**From:** Jerry Shaw <shawjerry.ca@gmail.com>  
**Sent:** Wednesday, December 20, 2017 3:19 PM  
**To:** David Kornfield  
**Cc:** Jerry Shaw  
**Subject:** 2046 Kent Drive additional inputs based upon new disclosures  
**Attachments:** 2046 Kent Presentation Shaw rev4.pptx; Pats Presentation rev1.pptx

**RE:** 2046 Kent Drive Design Review Commission inputs for tonight's 7 pm meeting at the planning department

# 12-20-2017 Design Review Commission

### 2046 Kent Ridgeline height to existing slab is actually (dwg. A10,A8,A7,A7A

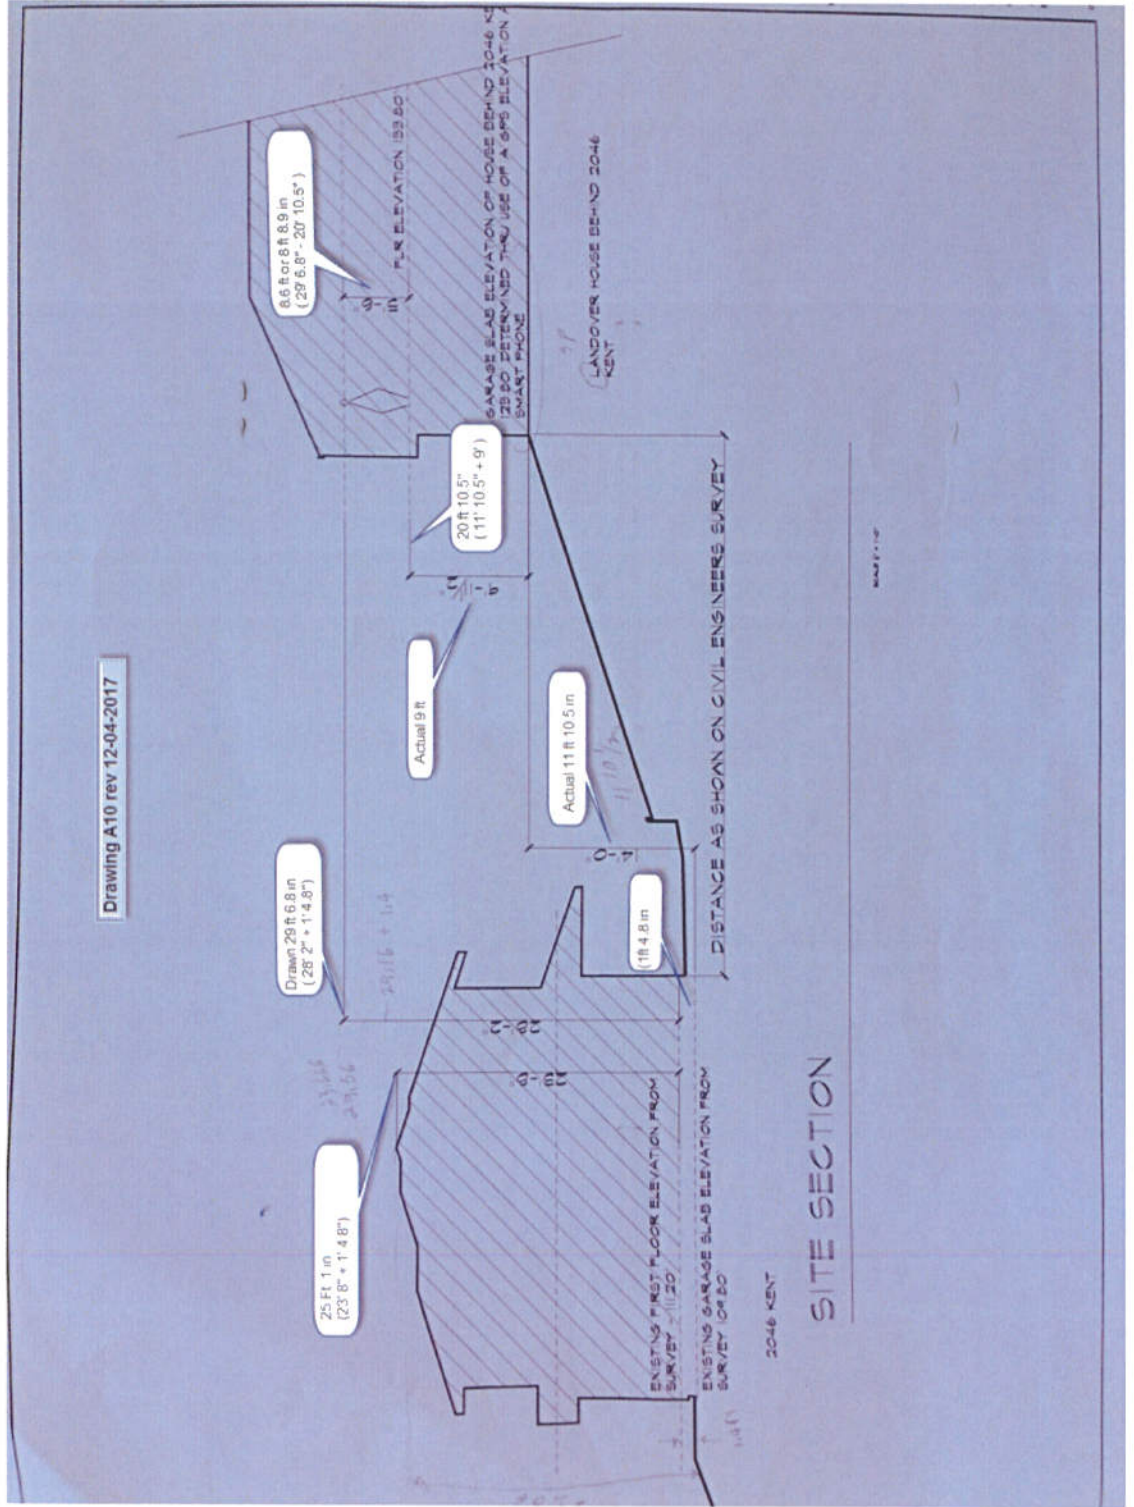
### 2046 Kent to 974 Andover Garage to Garage slab discrepancy (dwg. A10)

- updated measurement to 11 ft. 10.5 in. vs. original 14 ft. presented (~2 ft. lower error)
- (slab to 2<sup>nd</sup> floor elevation 974) 9 ft. 11 ½ in vs measured 9ft floor elevation (~11 ½ in lower)

Resulting Impact is the 2046 Kent slab to Andover 2<sup>nd</sup> floor elevation is significantly in error 20 ft. - 10.5 in vs 23 ft.- 11.5 in (difference of 3 ft. – 1.5 in.)

- 1<sup>st</sup> floor to slab elevation height not used for ridge height under valuing by 1.4 ft. (1 ft. 4.8 in.)
- The height 2046 Kent slab to 1<sup>st</sup> floor 1.4ft ( 1Ft 5in) not in 23ft 8 in ridgeline calculation
- Bottom line: Actual slab to ridgeline is 25 Ft

# Family room view impact - Superimposed Drawing

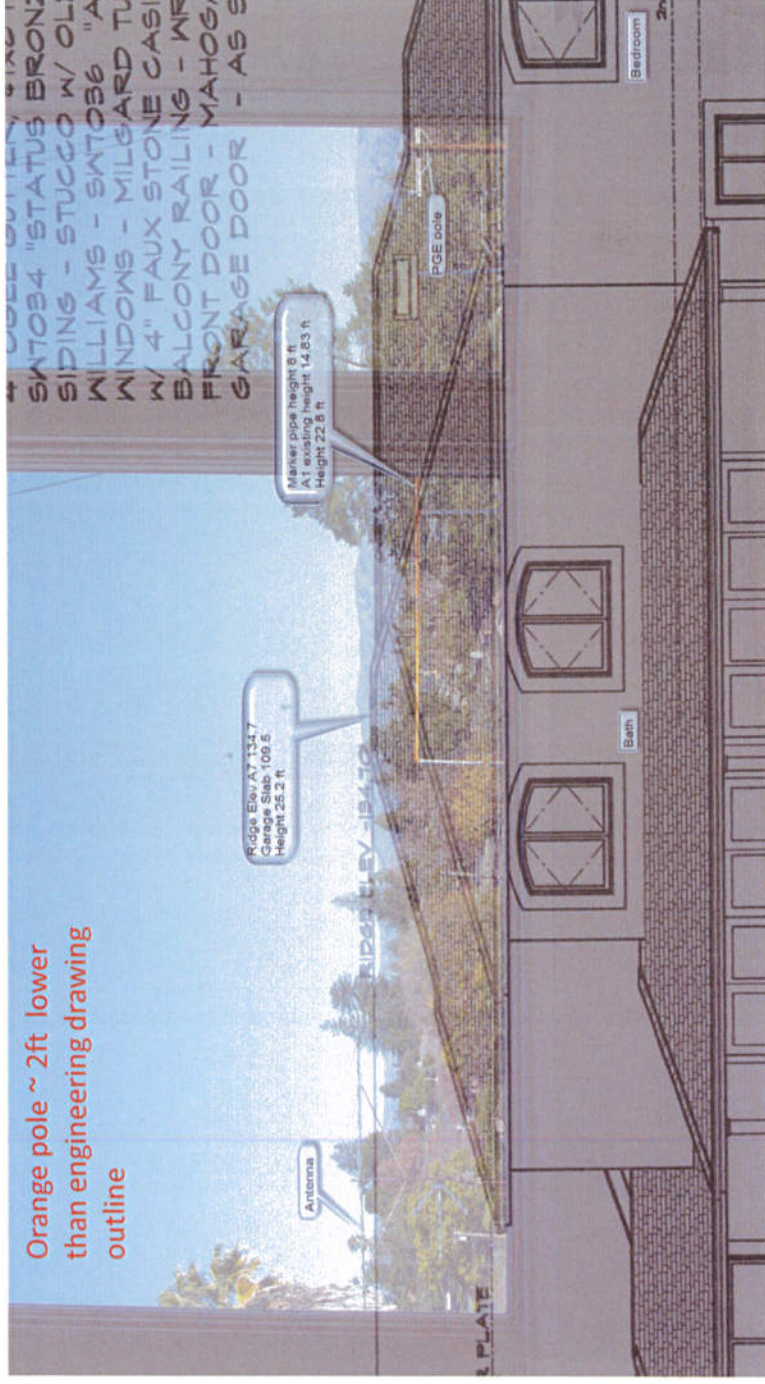
- Near field view impact significant
- Orange Post aided ridgeline photo alignment - bay window to A7 drawing
- Ridgeline height (~25ft) is closer to antenna than orange outline pipes

# Deck View - Superimposed Drawing

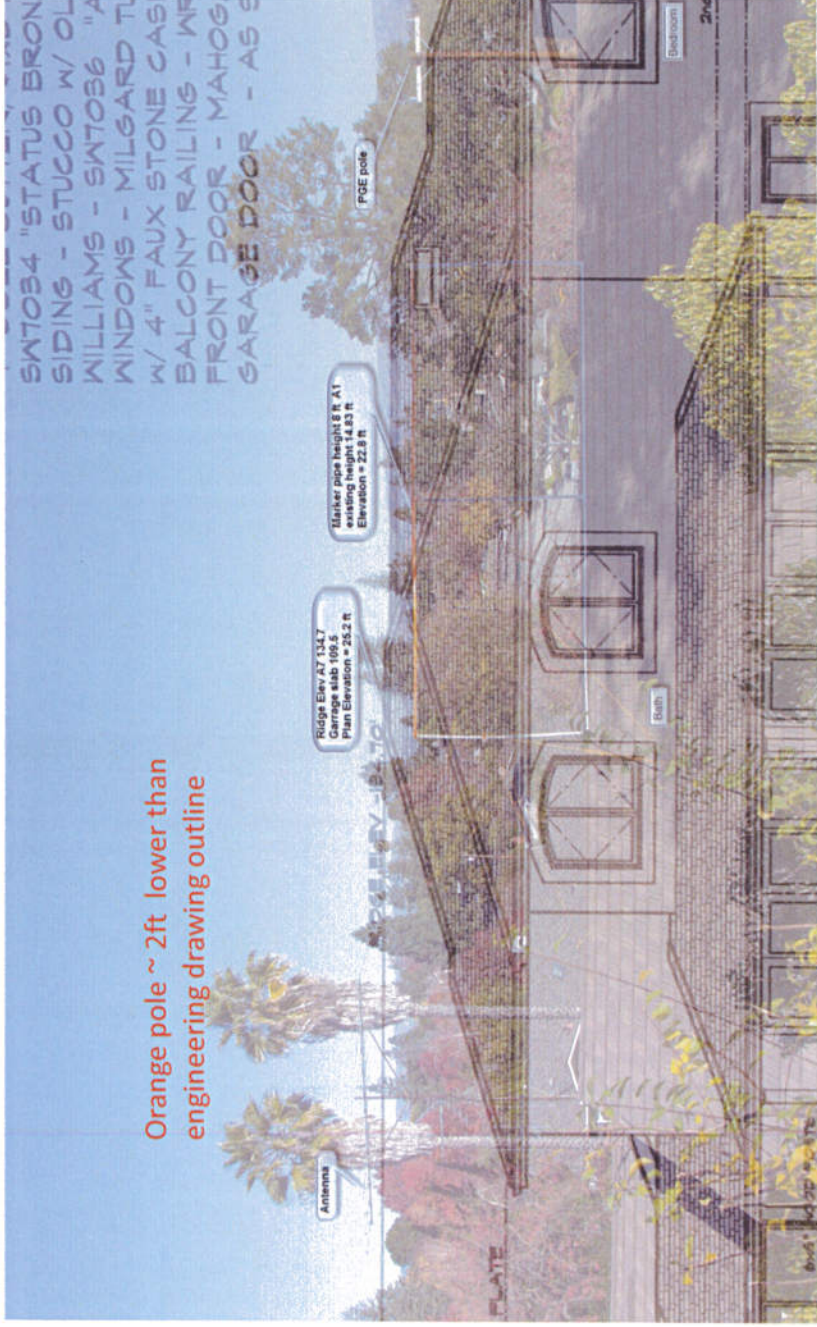
- Greater impact to deck & rear yard
- Deck is 8 inches ( 3/4 ft. ) lower than Family room floor
- Orange post aided ridgeline photo alignment - bay window to A7 drawing
- Ridgeline height (~25ft) is closer to antenna than orange outline pipes
